UNITED STATES PATENT AND TRADEMARK OFFICE

Office Action Summary	Application No. 10/804,595	Applicant(s) RUBIE ET AL.	
	Examiner Cheryl Miller	Art Unit 3738

DETAILED ACTION

Attachment #2 (marked up)

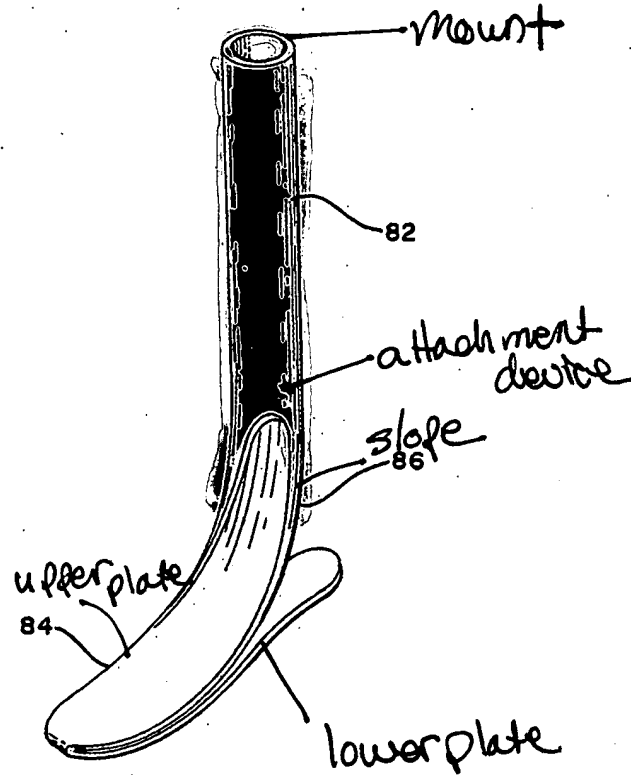
Claims 25-26, 28-33, 39, 40, 41, and 47-48 are rejected under 35 U.S.C. 102(b) as being anticipated by Chen (US 5,507,838). Chen discloses a lower leg prosthesis comprising a curved upper plate (40, 41), a lower plate (30, 31), and an attachment device (4; 42) coupled and conforming to the upper plate (see fig.4, 5). Chen discloses the attachment device to comprise a wedge shaped portion conforming to the upper plate, a horizontal mounting portion and a pyramid projection (see attachment 2). Chen discloses a weight reducing cutout in a forward

portion of the attachment device (see attachment 2; figs. 4, 5). Chen discloses a forefoot (30) and heel portion (31) being separated by a gap (near where 6 is located).
